GENERAL MOTORS
DCS7217
URGENT - DISTRIBUTE IMMEDIATELY

Subject: N252503100 - Service Update
First Responders Service Label Missing

Models: 2025 Cadillac Escalade IQ
2024-2025 Chevrolet Silverado EV
2022-2025 GMC HUMMER EV Pickup
2024-2025 GMC HUMMER EV SUV
2024-2025 GMC Sierra EV

N252503100 First Responders Service Label Missing

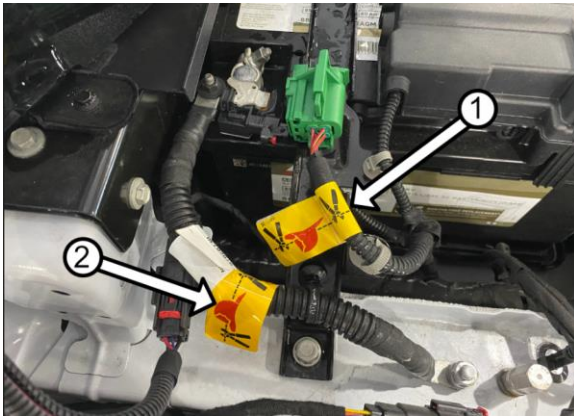
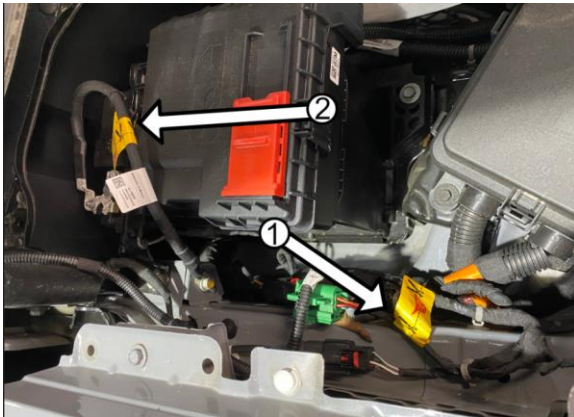
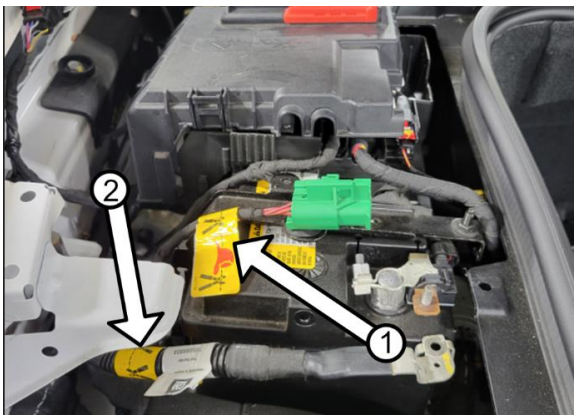
Condition	On certain vehicles listed above, the 12V Battery Negative Cable was erroneously labeled with a First Responder Emergency Cut Loop label.
Correction	Dealers are to inspect and ensure that the High Voltage Service Lockout Harness has the Emergency Cut Loop label installed and the 12V Battery Negative Cable does not have the Emergency Cut Loop label installed.

2. Inspect the High Voltage Service Lockout Harness for an Emergency Cut Loop label (1):
 - If the High Voltage Service Lockout Harness has an Emergency Cut Loop label applied (1), proceed to Step 4.
 - If the High Voltage Service Lockout Harness DOES NOT have an Emergency Cut Loop label (1) applied, proceed to Step 3.
3. Install the Emergency Cut Loop label to the High Voltage Service Lockout Harness.
4. Inspect the 12V Battery Negative Cable for an Emergency Cut Loop label (2):
 - If the 12V Battery Negative Cable has the Emergency Cut Loop label applied, proceed to Step 5.
 - If the 12V Battery Negative Cable DOES NOT have the Emergency Cut Loop label applied, proceed to Step 6.

5. Using a sharp cutting tool, remove the Emergency Cut Loop label from the 12V Battery Negative Cable.
6. Install the Right Front Compartment Rear Sight Shield. Refer to *Front Compartment Rear Sight Shield Replacement - Right Side* in SI.
